Access Compliance Report

Public Rights-of-Way (Curb Ramps)

Intersection ID: N/A	Main Street: ARBOR_LOOP_DR	Cross Street: POTOMAC_RIVER_PY	Location: NE
ADA ID: 630F2F224097	Ramp Type: Directional1	Initial Pass/Fail: Fail	Overall Compliance: No
		Severity Score: 1.25

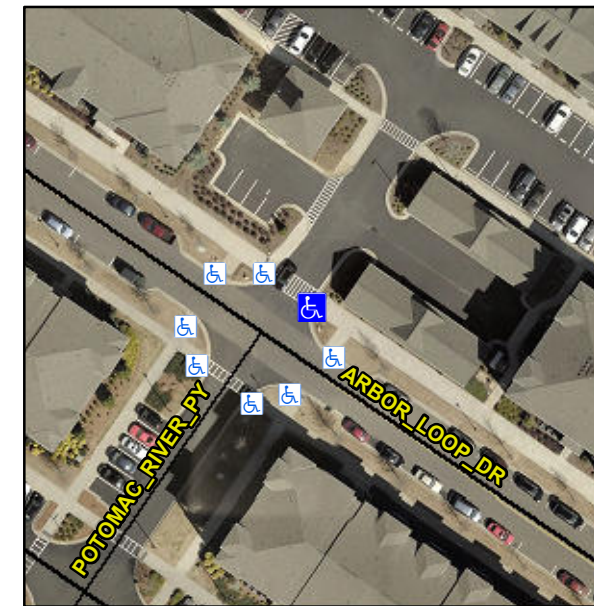
R304.5.3

Remove & Replace Entire Ramp.
